Ref: 10484

RESPONSE TO INITIAL REVIEW OF STORMWATER MANAGEMENT FOR PRIVATE PLAN CHANGE – DARGAVILLE RACING CLUB INCORPORATED.

Figure 1 - Lidar Terrain Surface (Source: LINZ)

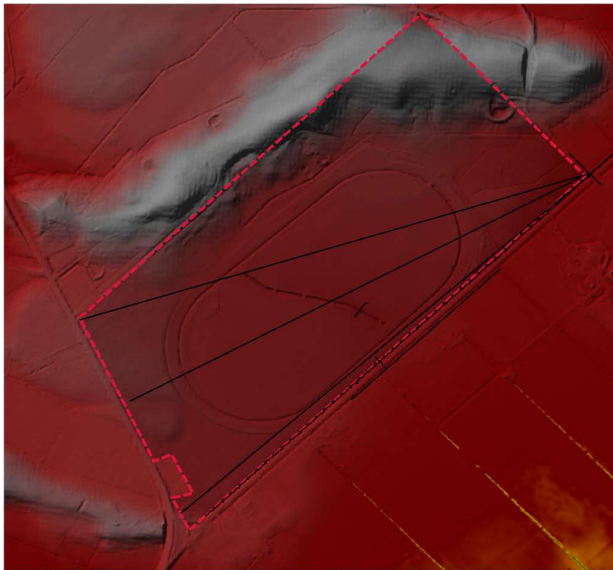
“Given the low-lying nature of the site, it is unclear how future stormwater networks and ponds will drain into the existing downstream drains without extensive fill earthworks.”

Although the site is relatively flat, it must be noted that there is a generous fall across the site towards Awakino North Road, which will facilitate good surface drainage. Obviously, the site will undergo surface terrain modifications and recontouring at the development stage, to direct runoff to the points of treatment, attenuation and discharge.

The elevations of development areas across the terrain ranges between 8.0 NZVD and 4.5 NZVD, with the invert level of the roadside drainage at the lowest point of discharge being at 3.3 NZVD. The details of how the terrain will be modified through a cut and fill operation and how the surface and subsurface drainage will function is

Figures 1 and 2 above shows the slopes of 3 sections taken across the site towards the lowest point of discharge in the north-east corner. The average slopes are measured as being 4.0 to 4.5%, which is considered adequate to drain into the existing downstream networks.

Figure 3 - 2D Surface drainage - 1% AEP Event

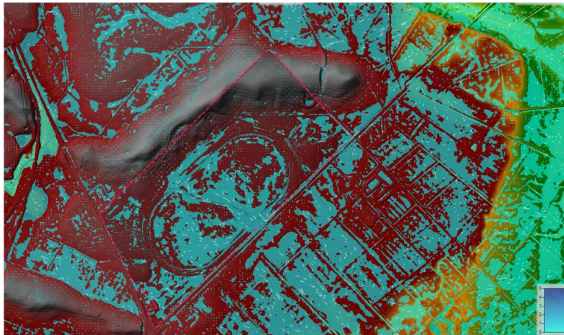
“It is not clear whether the stormwater infrastructure in the area will have capacity to cater to the requirements of design periods for commercial land use i.e. 5% AEP. An upgrade of infrastructure may be required to provide a suitable level of service to the development.”

The NRC River Flood Hazard maps indicates that the surrounding and downstream area is subject to flooding in 1%, 2% and 10%AEP events. A simulation with the aid of 2D hydraulic modelling software was undertaken to understand the overland and surface drainage from the site towards the flood susceptible areas and discharge points and test the capacity of the existing roadside table drains and downstream drainage network for the various events, up to and including the 1% AEP rainfall event.

Figure 4 above clearly depicts that the surface flows from the site for the 5% AEP event is mostly contained within the roadside drain, which discharges towards the northeast, whereas the larger 1% AEP event depicted in figure 3 is expected to flood across Awakino North Road.

Figure 6 - Subject site catchment of influence.

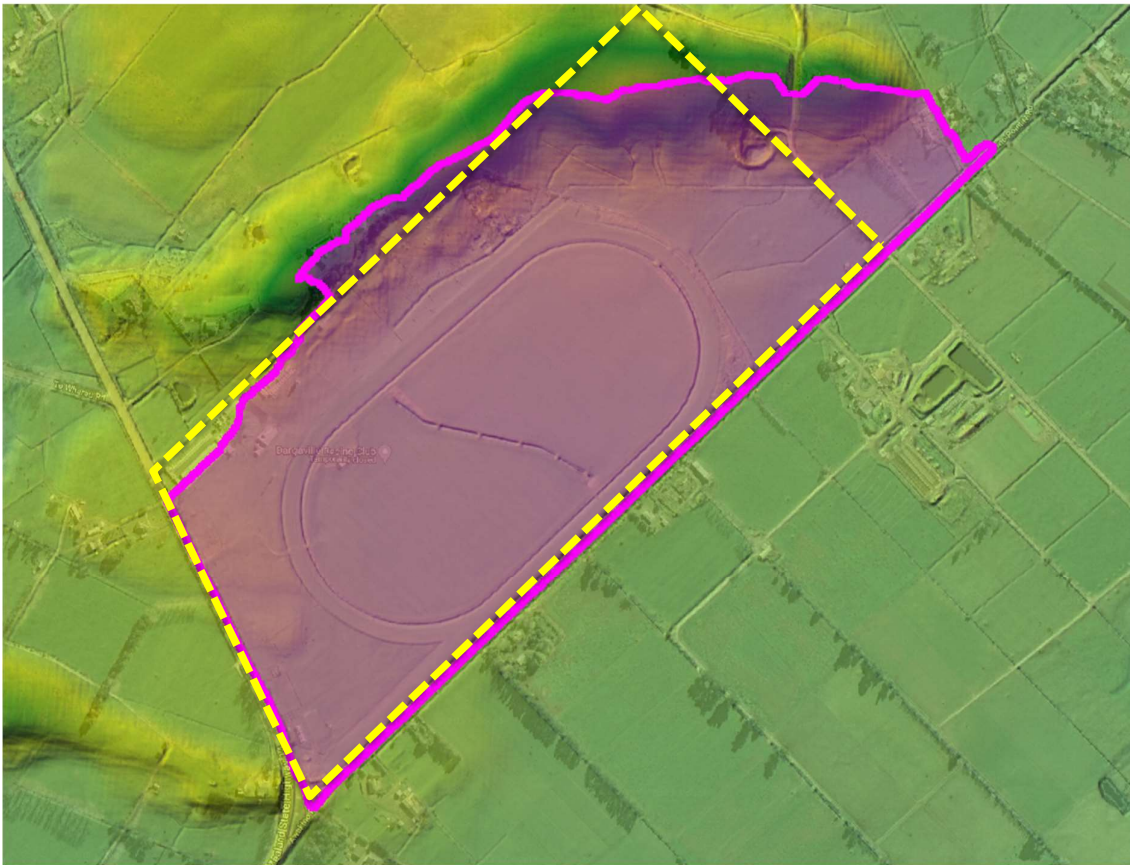
“The assessment does not appear to have considered the upstream catchment draining into the site which could both be impacted by the proposed development, and could impact the development.”

A detailed catchment delineation was undertaken to understand the wider catchment area contributing to flow in the downstream infrastructure (“catchment of influence”) and the potential effect the development may have on runoff from an upstream contributing catchment area. The catchment delineation shown in Figure 6 below, clearly depicts that the “catchment of influence” is mostly contained within the boundaries of the site. The delineated “catchment of influence” is measured as 50.6ha, compared to the overall surveyed site area included in the assessment in section 4.2.5 of our report of 45.06ha. The variation on the catchment area is attributed to road surfaces downstream of the site (drains within Awakino North Road and lower parts of Part Lot 35 DP 11124) and a part of Part Lot 36 DP 11719 draining into the site. The additional predevelopment flows from Part Lot 36 DP 11719 can easily be managed through the proposed drainage infrastructure and conveyed through the site.

There is not expected to be any effect on the ability to drain Part Lot 36 DP 11719 through the subject site, where the inflows are from the upper parts of the catchment, some 7 meters higher than the highest development area within the subject site. Therefore, we conclude that the effects from the upstream catchment draining into the site are less than minor.

Figure 8 - Simple hydrograph comparison depicting TC variation.

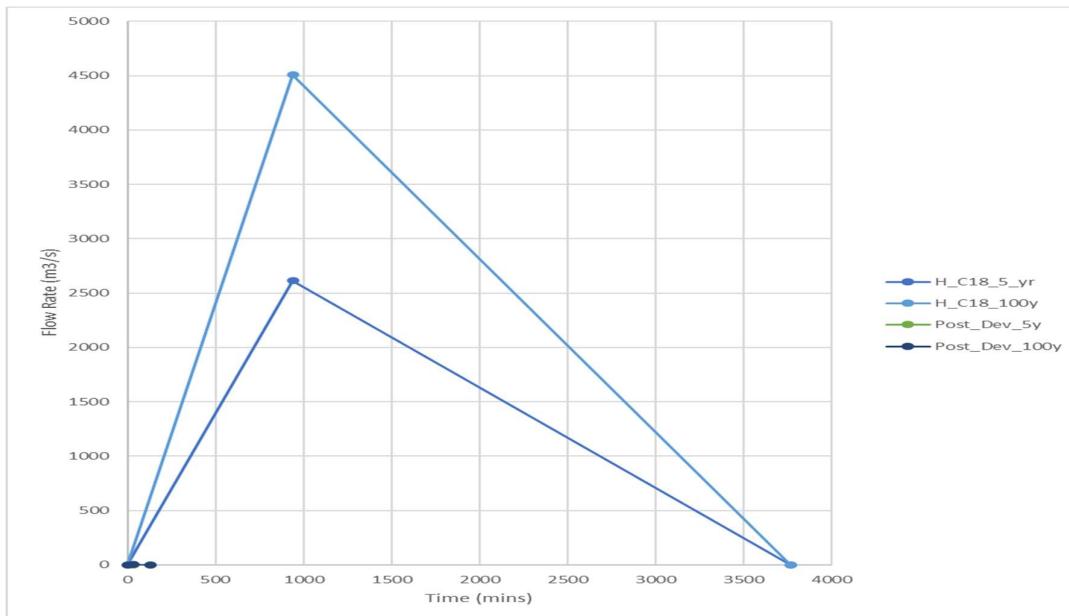
“Whilst the applicant has proposed stormwater attenuation devices to mitigate the effects of increased impervious area, they have not assessed what the potential impact the development will have on downstream flooding, in terms of the displaced ponding on the site.”

The Wairoa River has a catchment area of 2827km², with the longest flow path being approximately 127km. The time of concentration for the river reach near the subject sites point of discharge where flooding may be of concern is estimated as 25.5 hours using Ramser Kirpich formula.

The simulations included in our engineering assessment report, suggests the time of concentration for peak discharge to reach the discharge points of concern is approximately 45minutes. Therefore, any additional runoff

volume from the subject site, that is conveyed off the site and discharged, prior to the peak rainfall intensity that is expected to drive the peak discharge, will have little effect of the conveyance capacity of downstream infrastructure, and almost certainly no impact on downstream flooding due to the substantial variation and extreme unlikely circumstances where the additional volume being discharge will influence or coincide with the peak river flood.
